**Economic and Social Council**Distr.: General
26 February 2019

World Forum for Harmonization of Vehicle Regulations**Working Party on Passive Safety****Sixty-fifth session**

UN Global Technical Regulation No. 7 (Head restraints)**Proposal for Amendment 1 of Phase 2 of UN Global
Technical Regulation No. 7 (Head restraints)****Submitted by the Informal Working Group on the Phase 2 of UN
Global Technical Regulation No. 7***

Figure 1-1
Goniometry in the test procedure using apparatus that facilitate the measurement of coordinates.

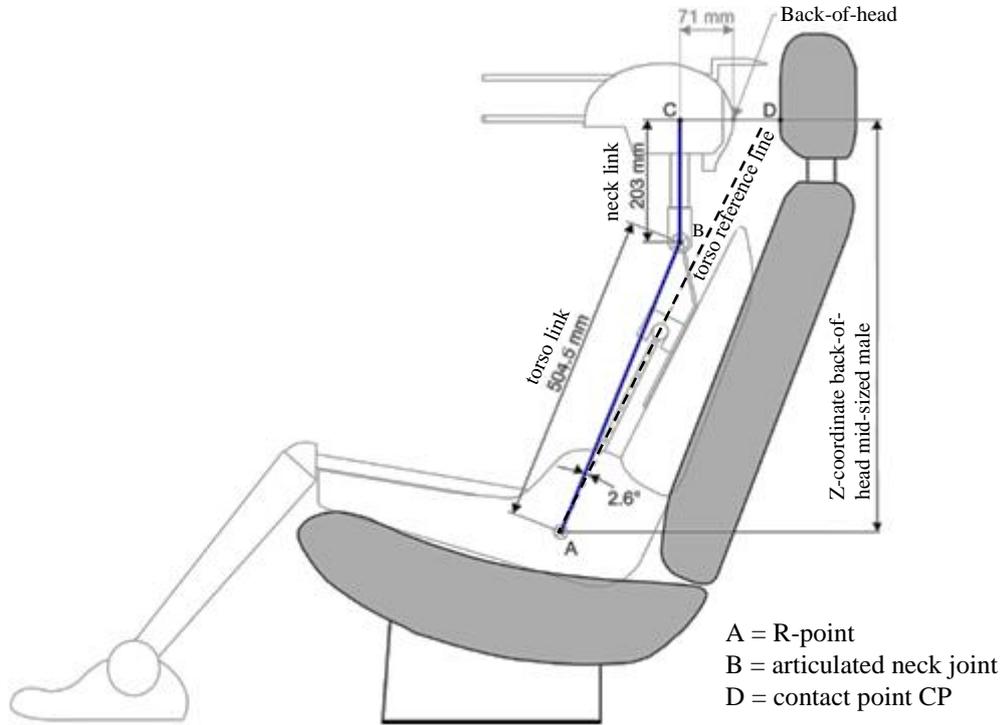
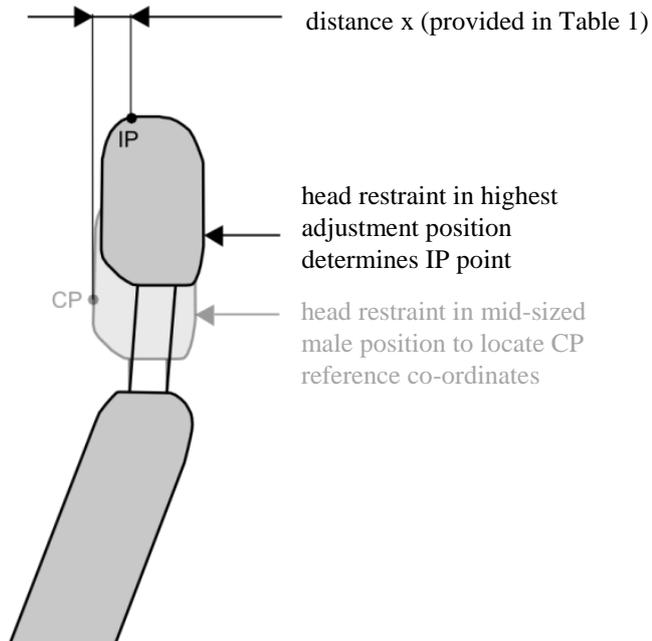
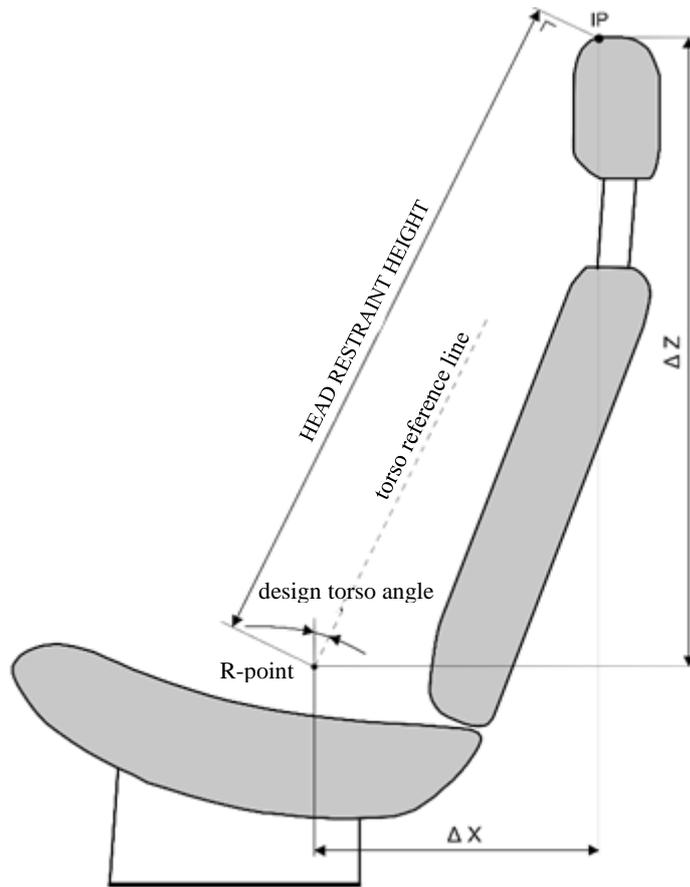
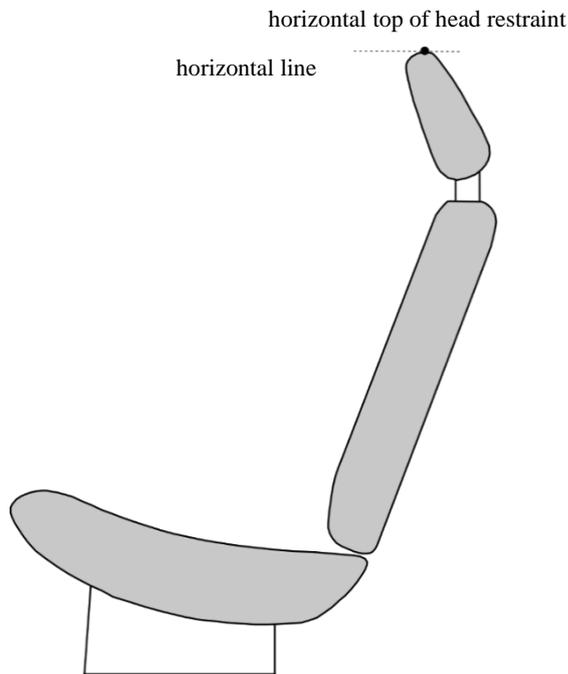
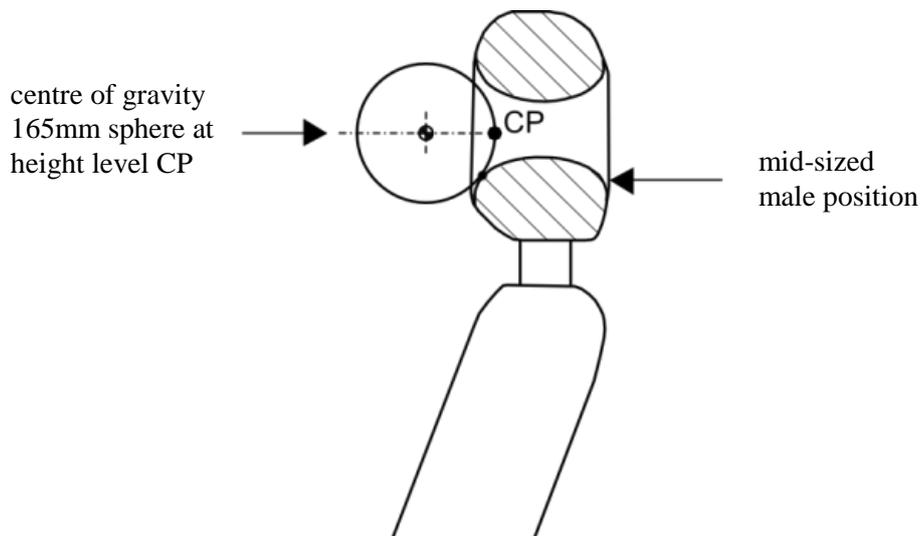
The height measurement ~~apparatus~~ **consists of (see Figure 1-1): is based on the use of an apparatus that facilitates the measurement of coordinates.**

The CP is defined as the intersection of a horizontal line, on the height of the Z-coordinate of the back-of-head of the mid-sized male (as given in table 1), with the front surface of the head restraint as indicated in Figure 1-1.

IP is determined on the front surface of the head restraint as the intersection with a vertical line rearwards of CP (see Figure 1-2) at the "distance x" (as given in table 1).

Where IP would be located rearwards of the horizontal top of the head restraint, IP will be designated at the horizontal top of the head restraint (see Figure 1-4).

The head restraint height is the distance from the R-point, parallel to the torso reference line and limited by a line perpendicular to the torso reference line intersecting IP (see Figure 1-3).

Figure ~~6-1~~ **5-1**

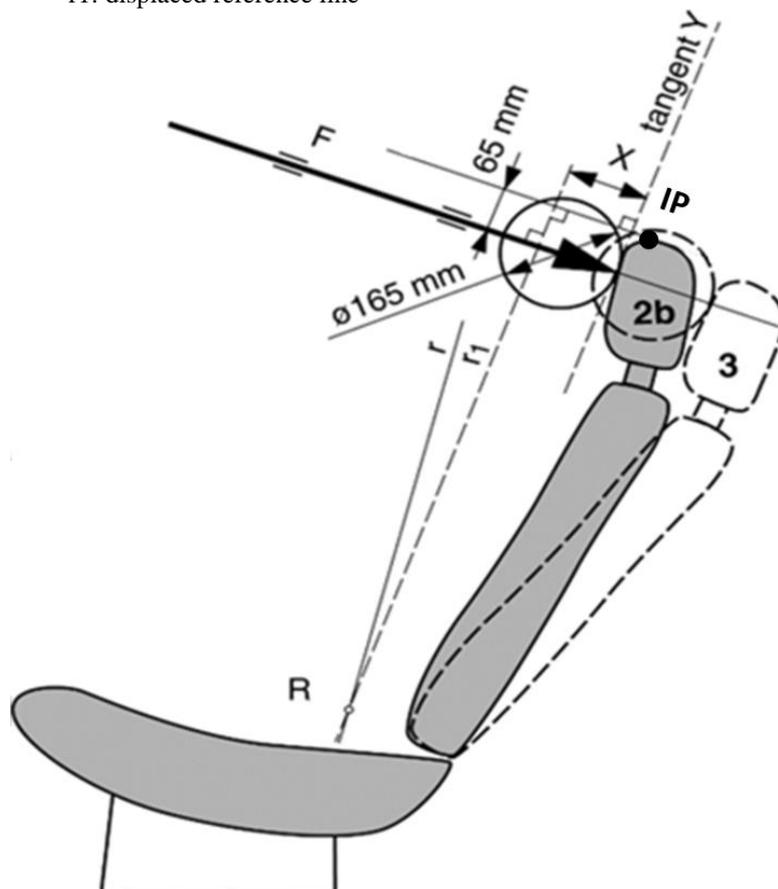
- 2.3. Establish the displaced torso line by creating a rearward moment of 373 ± 7.5 Nm about the R-point by applying a force to the seat back through the back pan at the rate of [2.5 Nm/second to ~~37.3~~ **3.7** Nm/second.] The initial location on the back pan of the moment generating force vector has a height of 290 mm \pm 13 mm. Apply the force vector normal to the torso line and maintain it within 2° of a vertical plane parallel to the vehicle vertical longitudinal zero plane. Constrain the back pan to rotate about the R-point. Rotate the force vector direction with the back pan. **In the case of simultaneous testing of bench seats, the rearward moment shall be applied to all seating positions of the bench simultaneously, irrespective of this position being equipped with or without head restraint.**

- 3.4. Establish the displaced torso line by creating a rearward moment of 373 ± 7.5 Nm about the R-point by applying a force to the seat back through the back pan at the rate between [2.5 Nm/second and ~~37.3~~ **3.7** Nm/second]. The initial location on the back pan of the moment generating force vector has a height of $290 \text{ mm} \pm 13 \text{ mm}$. Apply the force vector normal to the torso line and maintain it within 2° of a vertical plane parallel to the vehicle vertical longitudinal zero plane. Constrain the back pan to rotate about the R-point. Rotate the force vector direction with the back pan.

Figure 8-1

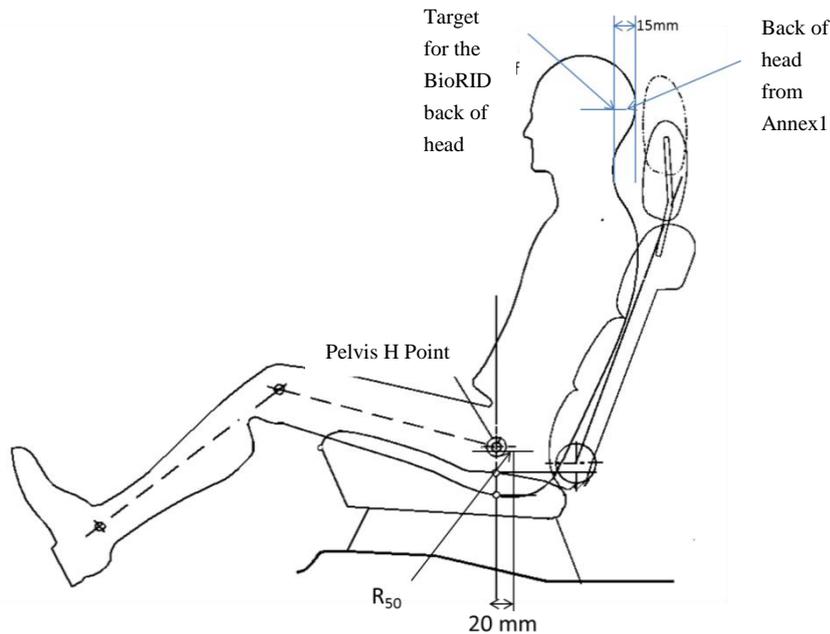
The back of the head reference position for the BioRID II is the value determined for the 50th percentile in Table 1, Annex 1 of this Regulation with reference to the specified torso angle minus 15 mm (increasing the backset as shown in figure 8-1).

Figure 9-1 8-2
Sled pulse acceleration corridor

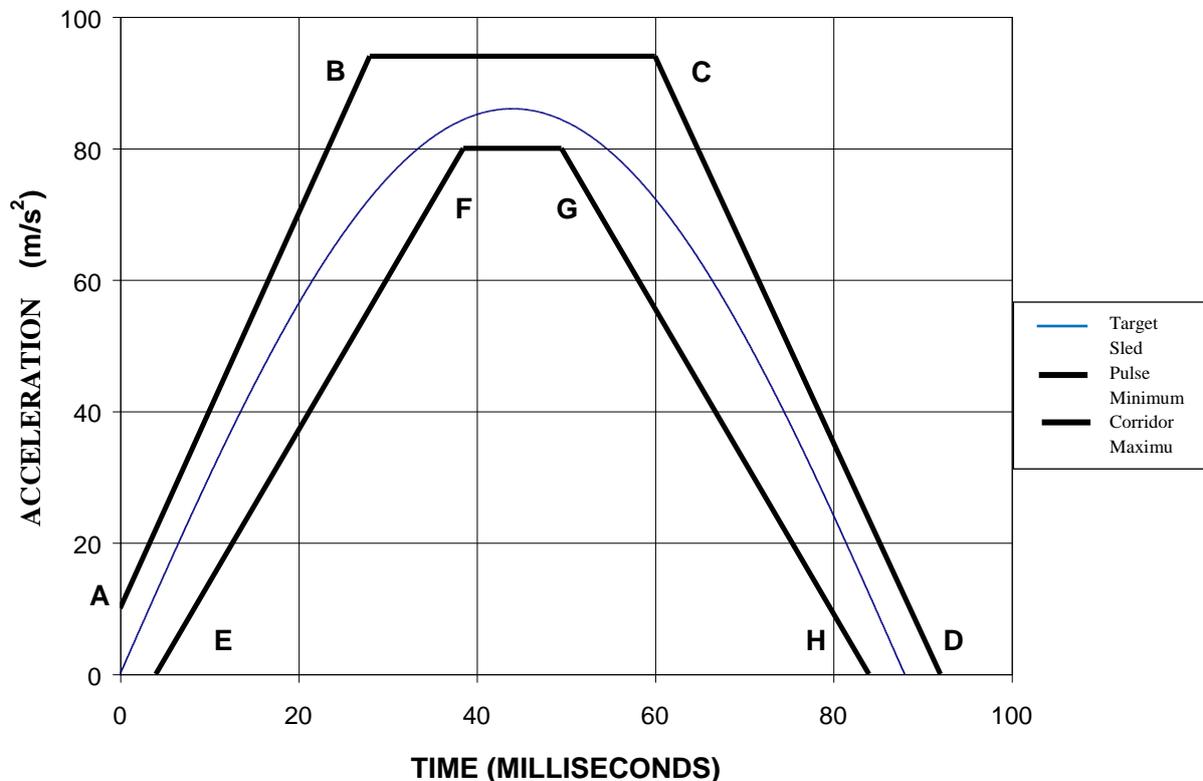
- ~~3.2~~ 3.1.2. Remove the tyres, wheels, fluids, and all unsecured components. Rigidly secure the engine, transmission, axles, exhaust system, vehicle frame and any other vehicle component necessary to assure that all points on the acceleration vs. time plot measured by an accelerometer on the dynamic test platform fall within the corridor described in Figure ~~9-1~~ 8-2 and Table ~~9-1~~ 8-1.

Reference Point	Time (ms)	Acceleration (m/s ²)
A	0	10
B	28	94
C	60	94
D	92	0
E	4	0
F	38.5	80
G	49.5	80
H	84	0

Figure 8-3
Acceleration versus time curve and Permissible Range of curve for the test set-up according to section 3.2. (The target acceleration with time expressed in milliseconds shall meet the value in the table 8-3.)

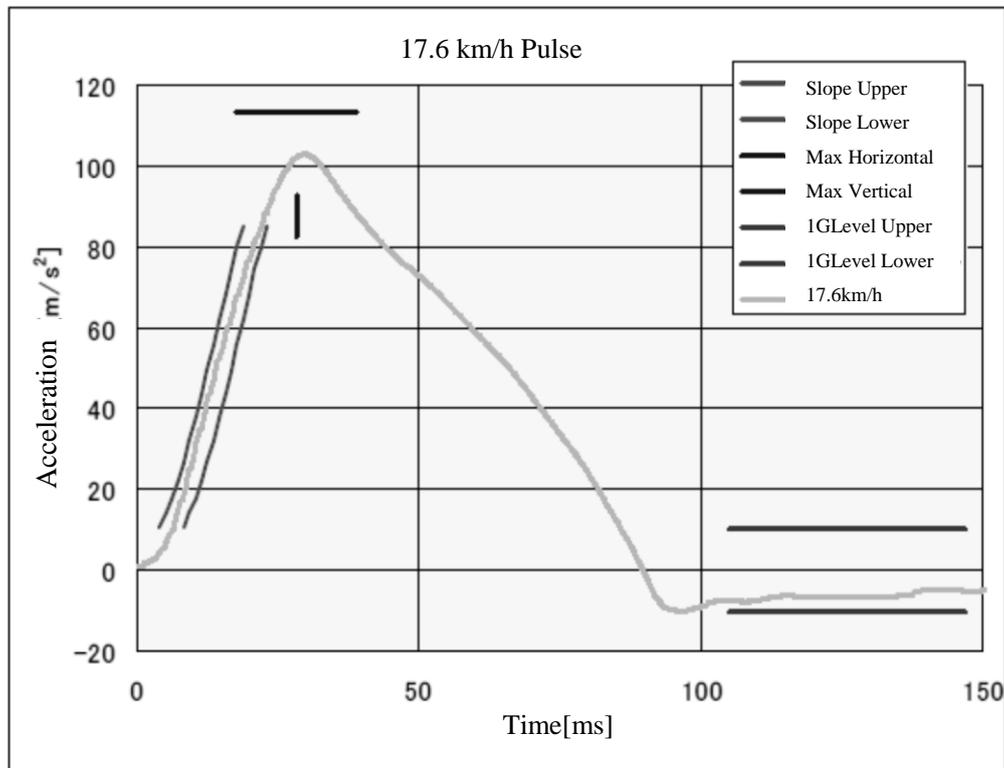
The corridors for the pulse are illustrated in Figure 8-3. The sled acceleration shall be adjusted within the corridors described in Figure 8-3 and Table 8-2 for the complete time interval from 0 to 0.15s. The sled pulse shall fulfil the requirements as specified in Table 8-3.
